## **Engineering Assessment Report**

Mixed Use Development at Clongriffin, Dublin 13  
Strategic Housing Development Application No. 2

August 2019

**Client Name:** Gerard Gannon Properties  
**Document Reference:** 18-059r.013  
**Project Number:** 18-059

**Figure 5: Parked vehicles in visibility splay**

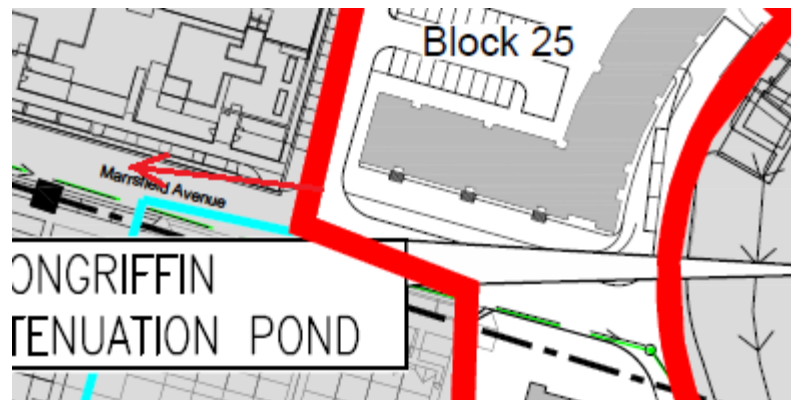
**2.1.4.4** A number of vehicles are parked within the carriageway on Marrsfield Avenue at the scheme tie-in, as shown in figure 4. Parked vehicles are obstructing the carriageway and creating obstructions in the visibility splay to the right from the new junction with the access into Block 25, as highlighted in figure 5. Parking spaces were also noted in close proximity to a number of other junctions throughout the site, where parked vehicles are likely to create obstructions and increase the risk of pulling out type incidents and right angled collisions, as well as rear shunt collisions.

2.1.4.1	Y	Y – Noted. Refer to Traffic Plan Report <sup>1</sup>		Y	
2.1.4.2	Y	Y - Rounded kerb edges are proposed for all parking bays.		Y	
2.1.4.3	Y	Y - Noted. Parallel parking spaces have been set back from junctions and visibility spays have been checked. Refer to revised drawings		Y

Figure 10

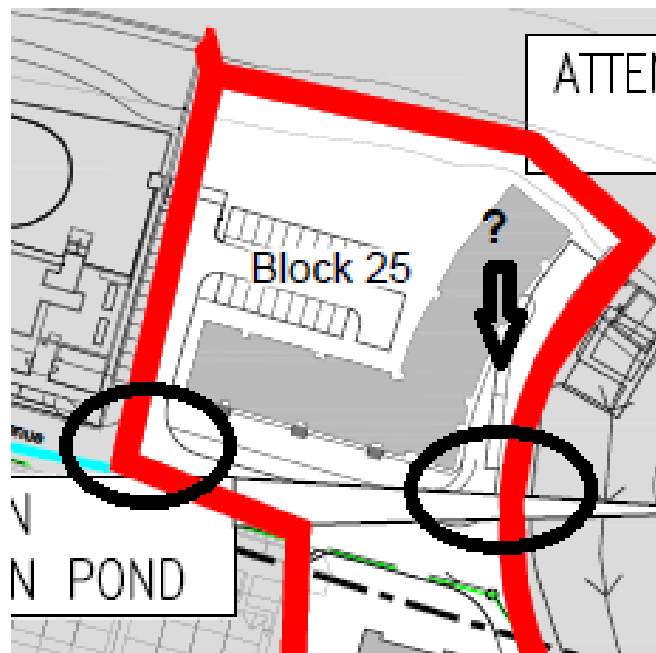
The details for the link to the east of block 25 at the north of the site are unclear, as the plan does not show kerb continuity and appears to show parallel parking spaces in the centre of the link. The priority and form of control at the two links to each side of block 25 are also unclear, as highlighted in figure 10. There is an existing substation at this location, and it is unclear if the substation will be retained, and if so, how access to and from the substation will be provided, as there is no provision for a turning circle at the northern end of the link, as shown in figure 11.

The layout and form of control at all intersection points and junctions throughout the site should be clearly shown on detailed design plans, with cross section and kerb details to be provided, to include dropped kerbs to facilitate vehicular access where necessary. Kerb continuity should also be shown in Railway Lane, and surrounding Block 28 adjacent to Station Street, where no kerblines have been shown between the building line and carriageway. Suitable turning circles should be provided on all cul-de-sac links throughout the site, and provision should be made for service and maintenance vehicle access where necessary. Detailed design should include for impact on the attenuation pond at the north of the site with provision for suitable fencing, earthworks and access.

Figure 11

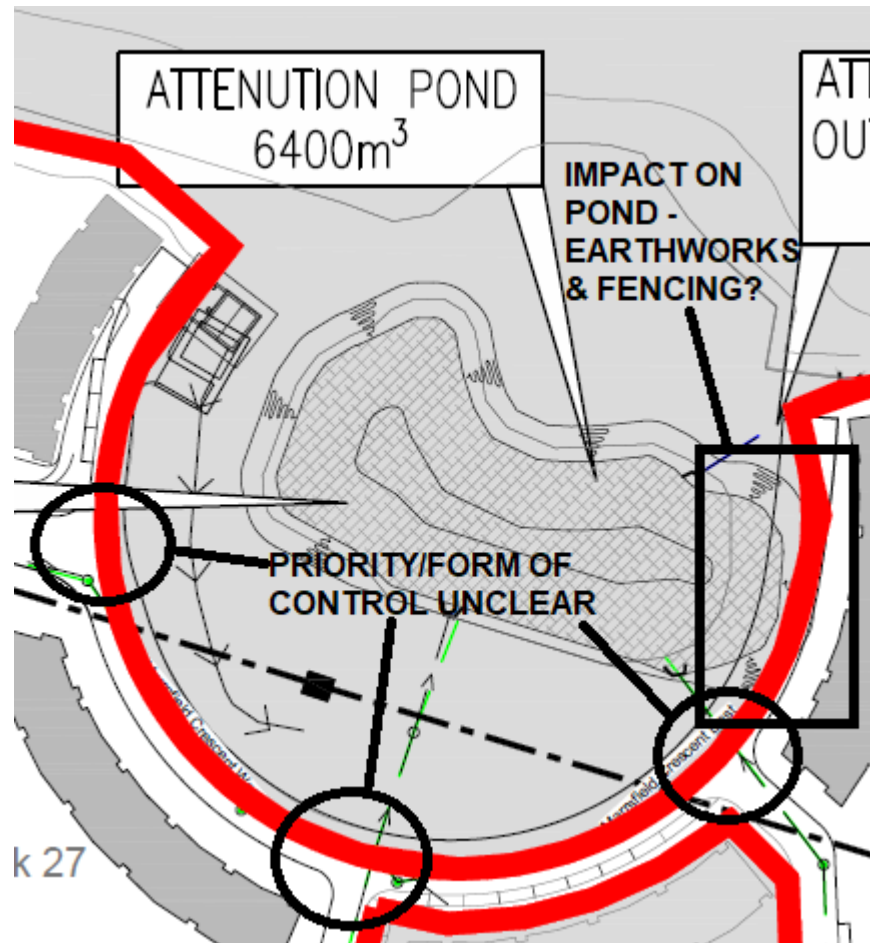
Figure 11 also shows a cul-de-sac link to the west of block 26 which will impact on the area of the existing attenuation pond, and there is no provision for earthworks and accommodation for the new pond area. There is also no provision for a turning circle or space for vehicles to turn at the northern end of this link. The priority and form of control at the other two junctions on the link surrounding the attenuation pond are also unclear, and there is no provision for fencing to protect VRUs from the water hazard and steep embankments, or for maintenance access to the pond.

**Figure 22**

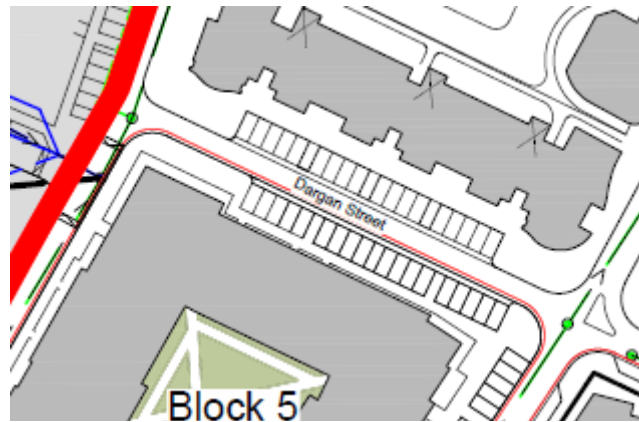
There was no swept path analysis provided to the Audit Team to demonstrate that the proposed layout will safely accommodate the swept paths of all anticipated vehicles with adequate margins of safety. The current geometry and cross section width appears restrictive on some links, particularly in the vicinity of tight radii on Lake Street and Clongriffin Rd, with examples shown in figures 19 to 22, and there has been no provision for cross section widening on any of the tight bends, which may present difficulties for safe two-way movement of larger vehicles. There are splitter islands also shown at some locations, as shown in figure 19, which will restrict some turning movements, however there were no details provided on proposed direction of circulation or permissible movements throughout the site. Elsewhere, splitter islands appeared to be located at kerblines, as shown in figure 23.

Drawing, P1130		
2.1.9	Y	Y - Refer to attached Landscape drawing		Y
2.1.10	Y	Y - Noted		Y
2.2.1	Y	Y - Noted		Y
2.2.2	Y	Y - : Refer to revised drawings and Auto Tracking drawing		Y

**Figure 33**

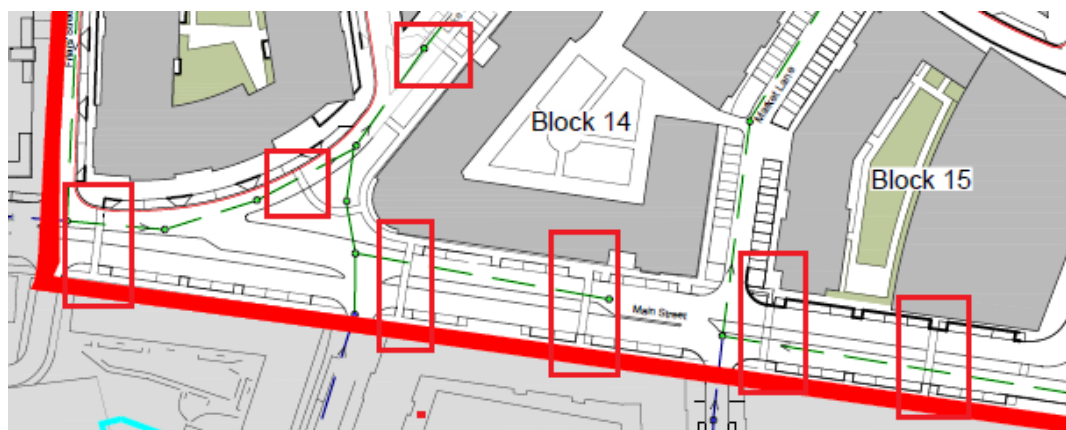
- Solid lines are shown across the carriageway at a number of locations on Main Street and Lake Street, which may represent proposed pedestrian crossing points, however there were no details provided at these locations, including form of control, configuration and width. It was noted that a number of these potential crossing points are located too close to adjacent junction and parking bays, where intervisibility may be reduced.

**Figure 37: Road Markings Showing Bus Access Only**

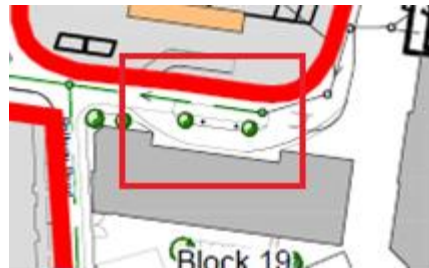
- The layout at Station Hill is misleading, with both lanes marked for buses only, but no warning signage from either direction on Station Street to prevent vehicles turning onto the link (see Photo in Figure 37 – poles are present, but there is no accompanying signage).
